January 30, 1998

98WLOL-0089-FE

Subject: Alcoa Remediation Projects Organization  
Waste Lubricating Oil Lagoon  
Final Inspection Reports

SEEPAGE BARRIER DETAIL

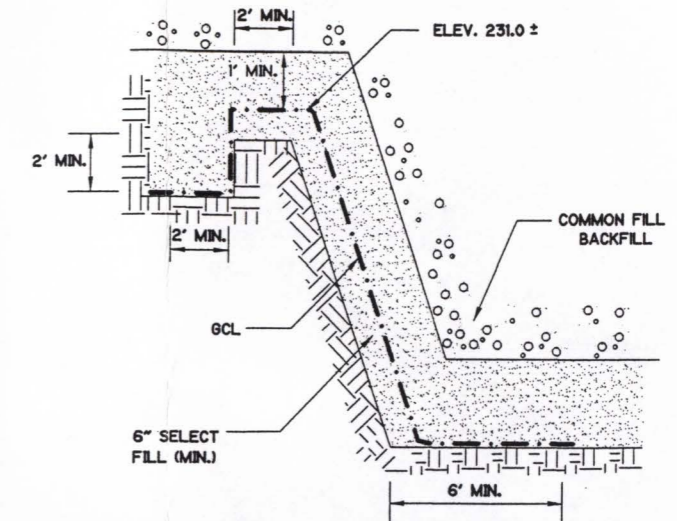
Contrary to the second sentence of the third paragraph on page 3-8, Record Drawing B-137714-JM does not show how the seepage barrier on the northeast and east sideslopes was installed.

**Acknowledged. A note has been added to Detail 3 on Record Drawing B-137714-JM to reflect the fact that a GCL anchor trench was not required on the northern and eastern berms.**

1. ANCHOR TRENCH WAS NOT REQUIRED FOR THE NORTHEAST AND EAST BERMS AS SHOWN IN PLAN VIEW ON DRAWING B-137711-JM.

UNDERDRAIN SUMP DETAIL

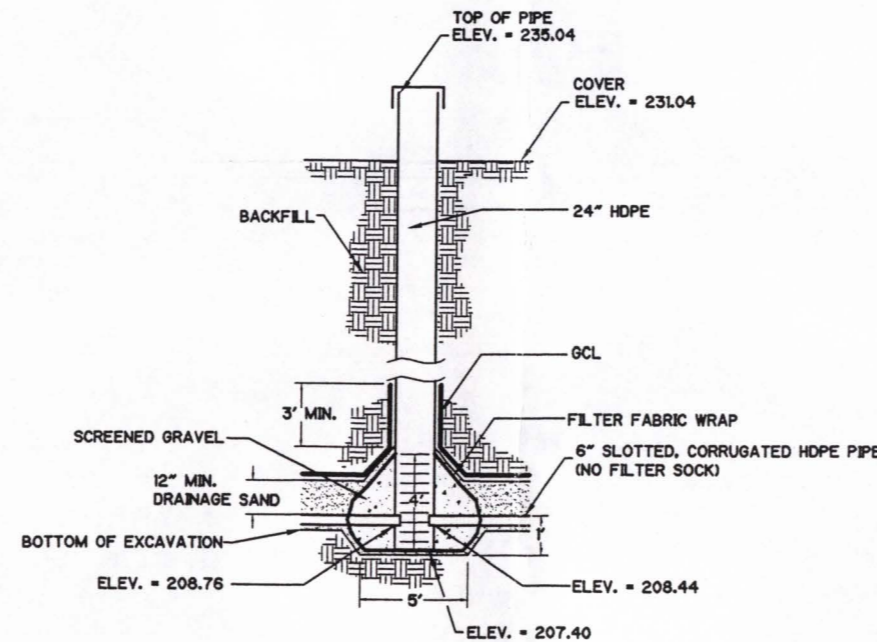
Comment: Drawing B-1137714-JM

With regard to the underdrain sump detail, the 6-inch slotted, corrugated HDPE pipe; the filter fabric wrap; and the screened gravel have all been mis-labeled.

**Acknowledged. The drawing has been revised.**
